Access Compliance Report Public Rights-of-Way (Curb Ramps)

Main Street: **ESPERANZA_RD** Cross Street: **N/A** Location: **N**

ADA ID: **RPAT220221121714** Ramp Type: **Type 4 - Parallel** Initial Pass/Fail: **Pass** Overall Compliance: **No** Severity Score: **0**

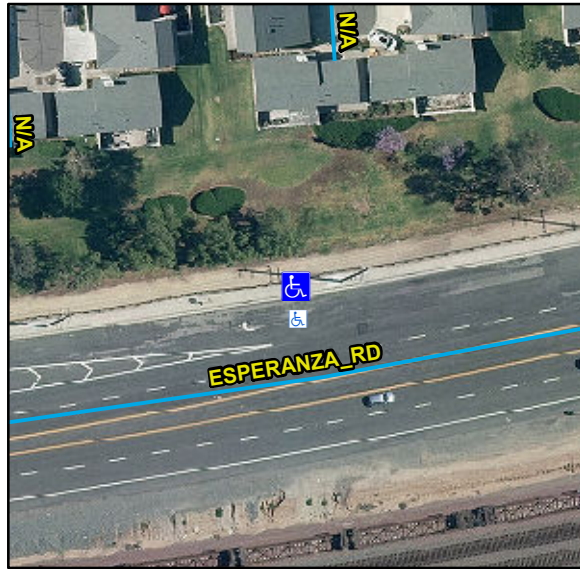
Gutter Ponding Observed.

R302.7, STD 1115
